**MISSILE ANALYSIS METHODOLOGY FOR GE NUCLEAR STEAM TURBINE ROTORS BY  
THE SWPC**

**THE NUCLEAR REGULATORY COMMISSION AS TOPICAL REPORT TP-03143-NP-A  
FOR PUBLIC RECORD**

**SUBJECT: SAFETY EVALUATION FOR ACCEPTANCE OF REFERENCING THE SIEMENS WESTINGHOUSE TOPICAL REPORT, "MISSILE ANALYSIS METHODOLOGY FOR GENERAL ELECTRIC (GE) NUCLEAR STEAM TURBINE ROTORS BY THE SIEMENS WESTINGHOUSE POWER CORPORATION (SWPC)" (TAC NO. MB5679)**

SAFETY EVALUATION BY THE OFFICE OF NUCLEAR REACTOR REGULATION

**Figure 3.2 Toughness ( $K_{1c}$ ) versus Excess Temperature**

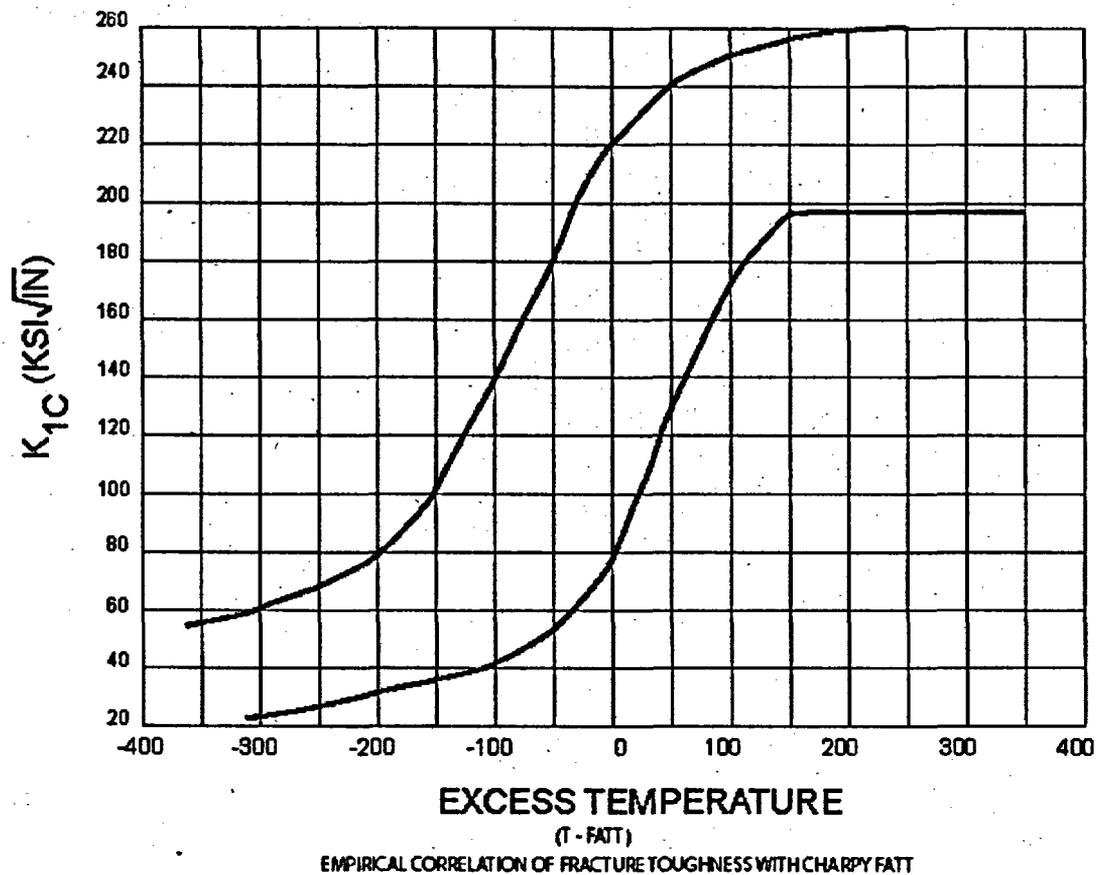
The NRC staff also questioned whether the standard deviation for  $K_{Ic}$  is large enough to account for the scatter and uncertainties associated with limited test data and whether a randomly selected  $K_{Ic}$  value used in the Monte-Carlo simulations might be unrealistically high. In response to this concern, SWPC decided to use [ ] percent of the mean  $K_{Ic}$  value as the standard deviation and use a value of [ ] ksi $\sqrt{in}$  for the maximum upper-shelf mean  $K_{Ic}$  value in its disk burst analysis. The staff considers these values to be acceptable because the same standard deviation for  $K_{Ic}$  and the maximum upper-shelf mean  $K_{Ic}$  value has been used successfully in vessel probabilistic fracture mechanics (PFM) analyses for twenty years for similar types of steels.

Since fracture toughness ( $K_{Ic}$ ) tests are not normally performed for turbine disks, the Westinghouse methodology obtained  $K_{Ic}$  values from measured Charpy V-notch (CVN) data and yield strength using the Rolfe-Barsom equation. Siemens also used this empirical equation to estimate  $K_{Ic}$  values for turbine disks in its proposed turbine missile methodology. In response to the NRC staff's concerns regarding the determination of  $K_{Ic}$  values using the Rolfe-Barsom equation, SWPC further clarified that the Siemens methodology will use the Rolfe-Barsom equation only for disks operating in the upper shelf region, and for disks operating below the upper shelf region, it will use a  $K_{Ic}$  and (T-FATT) correlation based on GE data, where FATT stands for the test-determined fracture appearance transition temperature. This procedure in determining the  $K_{Ic}$  values, which will be used as mean values in the subsequent Monte-Carlo simulations, is more rigorous than the previously approved ones, and is therefore acceptable to the NRC staff.
